HISTORIC AND DESIGN REVIEW COMMISSION

HDRC CASE NO: 2015-268 **ADDRESS:** 123 MAY

TYPE OF WORK: Construct detached storage/shop outbuilding

View of proposed location

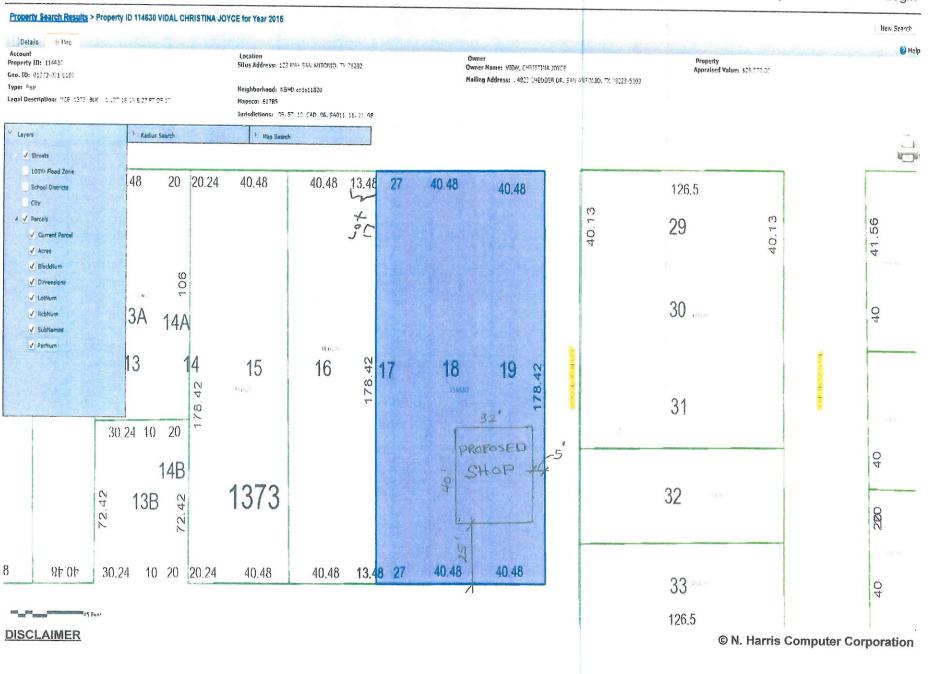
- f. Consistent with the Guidelines for New Construction, the historic setback pattern of similar structures along the streetscape or district should be followed. Historic garages and outbuildings are most typically located at the rear of the lot, behind the principal building. The proposed garage will be located on the front yard of the property and will align with the front of the main structure which is not consistent with the guidelines.

- a. New structure should relate to style and period of construction of the main house
- b. Reduce height to be more consistent with surrounding structures
- c. Garage should be located towards the rear of the property closer to Houston Street.
- d. Additional information including window specifications, foundation type, and dimensioned site plan is submitted for review.
